Access Compliance Report Public Rights-of-Way (Curb Ramps)

Main Street: TRISTANIA_ST		Cross Street: S_SELLAS_RD		Location:	NE
ADA ID: RPAT211102132538	Ramp Type: Type 4 - Parallel	Initial Pass/Fail: Fail	Overall Compliance: No	Severity Score:	2
Codes/Mitigation Info/Possible Solution			Field Measurements/Component Compliance

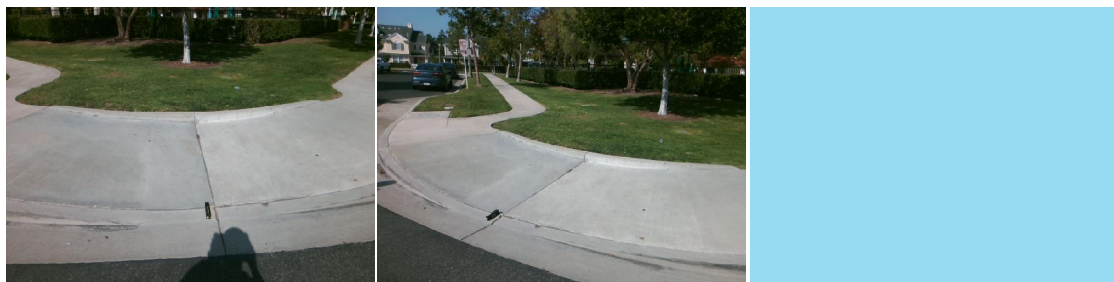
Compliance	Description	Data	Compliance	Description	Data
N/A	Ramp Length LT (in)	110	N/A	Ramp Length RT (in)	110
Yes	Ramp Width LT (in)	90	Yes	Ramp Width RT (in)	90
Yes	Ramp Run Slope LT (%)	4.5	Yes	Ramp Run Slope RT (%)	6.2
No	Ramp Cross Slope LT (%)	4.8	No	Ramp Cross Slope RT (%)	2.2
N/A	Landing Present	N/A	N/A	DWS Provided	N/A
N/A	Landing Length (in)	N/A	N/A	DWS Contrast	N/A
N/A	Landing Width (in)	N/A	N/A	DWS Length (in)	N/A
N/A	Landing Run Slope (%)	N/A	N/A	DWS Full Width	N/A
N/A	Landing Cross Slope (%)	N/A		DWS Offset Type	N/A
N/A	Landing Movement Obstructed?	N/A	N/A	DWS Offset Left (in)	N/A
	Landing Movement Type	N/A	N/A	DWS Offset Right (in)	N/A
N/A	Landing Shared	N/A			
N/A	Clear Space	Yes			
N/A	Clear Space To Crosswalk (in)	N/A			
N/A	Marked Crosswalk 1	No	N/A	Marked Crosswalk 2	No
	Crossing 1 Direction	SW		Crossing 2 Direction	SE
	Marked Crosswalk 1 Width (in)	N/A		Marked Crosswalk 2 Width (in)	N/A

Remove & Replace Curb Ramp With Two New Directional Ramps or Equivalent.
